**IDA referral for boatshed, ramp, slipway, jetty and steps.
316 Hudson Pde, Clareville (Lots 1 & 2, DP 827733) – Pittwater.**

The purpose of this correspondence is to seek your support for an amended design that we suggest satisfies your concerns and provides a superior solution with respect to key fish habitat to the simple like for like replacement of the previous structures.

Please see following and find attached a revised proposal that takes into account your recommendations.

2. Vertical Walls:

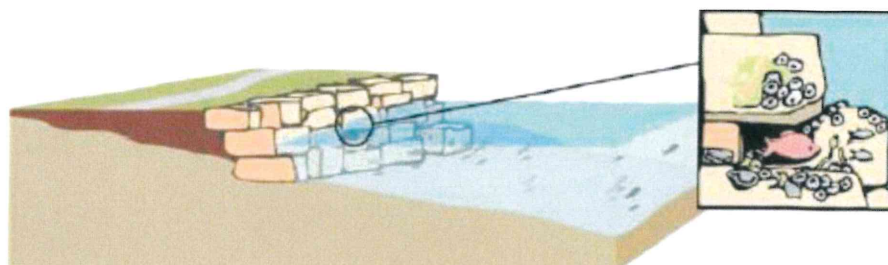
The walls that are proposed to be constructed will be replacing the walls that have existed on the site since at least 1947.

The coastal morphology and fish habitat has formed around these structures over the decades they have been in place and to remove them altogether has the potential to change the local morphology and thus threaten the existing habitat. (Ref Royal Haskoning and Bio Analysis reports)

Please note on the drawings that the all the outer vertical walls other than those under the ramp have been replaced with unbonded, stepped, sandstone blocks as per the, OEH Environmentally Friendly Seawalls Guide referenced in your referral responses.

These blocks will protect the facility from wave action while providing habitat in the intertidal zone.

Image 3 – Sea Grass adjacent proposed reinstated jetty (Ref: Bio Analysis Report)

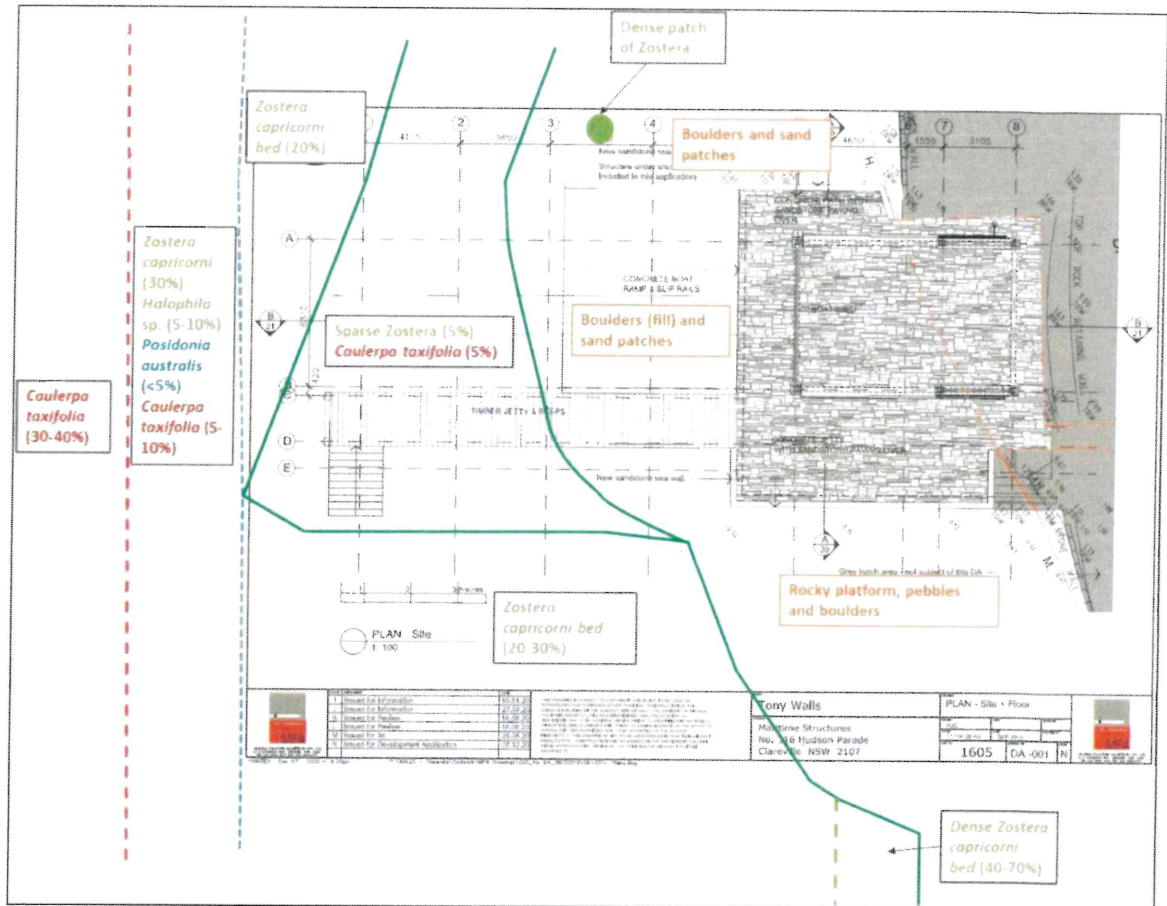
Reference to the sea grass map and images contained in the Bio- Analysis Report reveals that there is no sea grass under over one third of the proposed jetty and that the remaining section sees sparse *Zostera* seagrass of poor quality constitute less than 5% on the seabed. (Ref: Bio Analysis Report)

To this end the amended proposal sees the opaque timber boards of the prior and existing jetty and steps replaced with decking material specified to provide 50% light transmittance in accordance with your referral response.

These amendments will see a net improvement of the light transmitted to sea bed that will hopefully encourage an increasing density of sea grass.

Diagram 2B: Design Guidelines for conventional Jetty, Ramp and Pontoon Structure

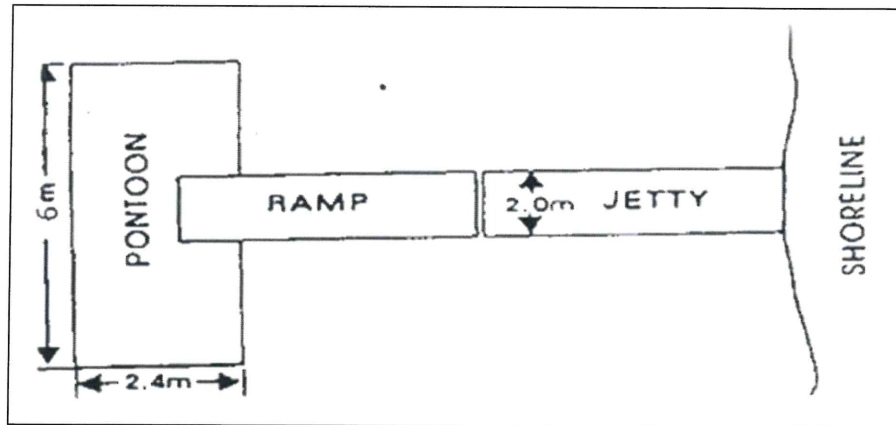
With the above in mind, we would ask that you support the proposed 2 metre width of the jetty in accordance with the NBC DCP.

Section AA
1: 50 @ A3

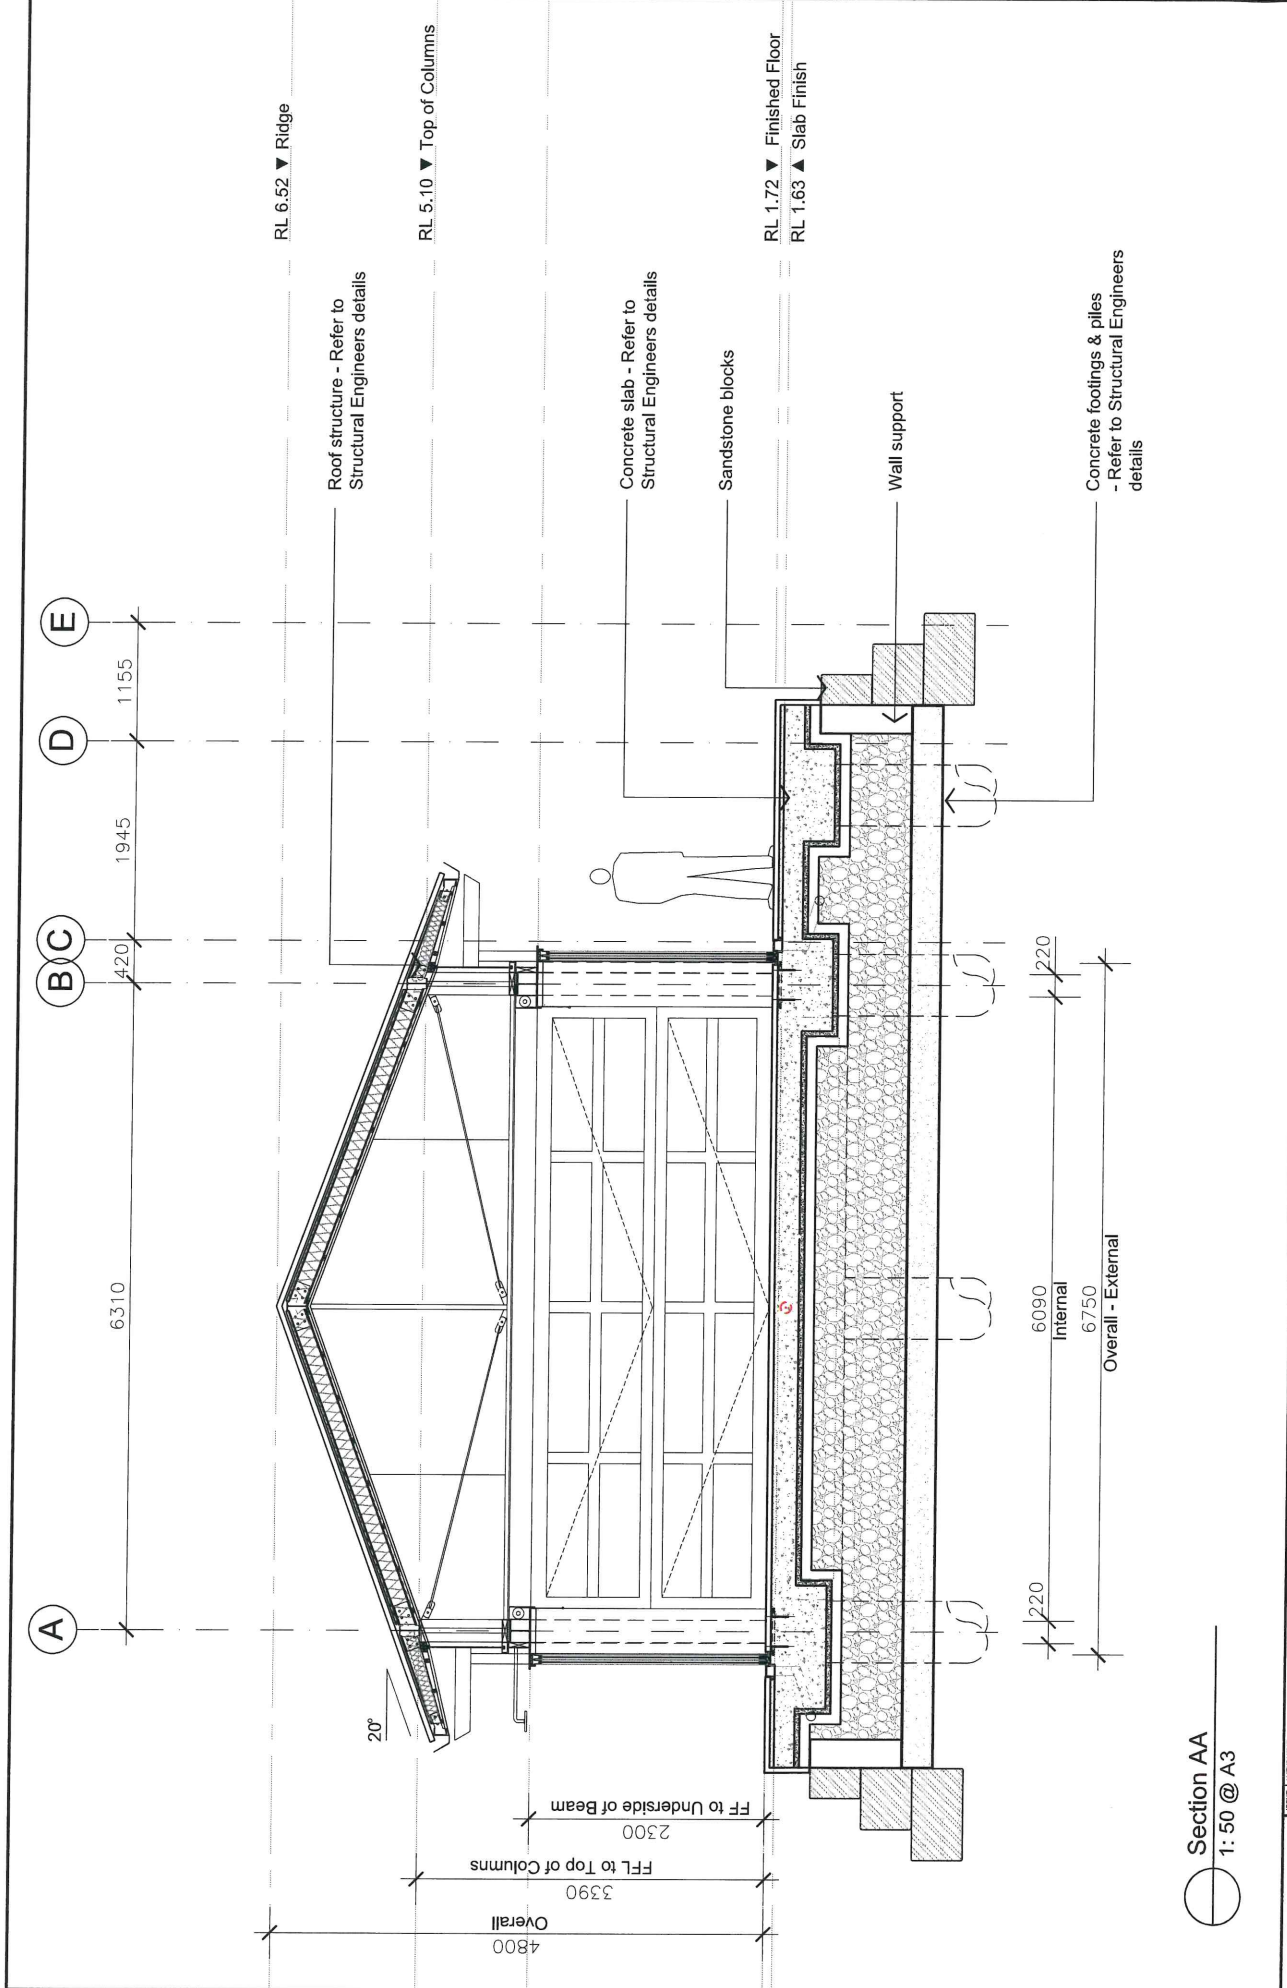
1. existing walls largely demolished,
2. development footprint reduced,
3. outer vertical walls deleted and replaced with stepped sandstone blocks,
4. and the jetty decking changed to provide 50% light transmittance.
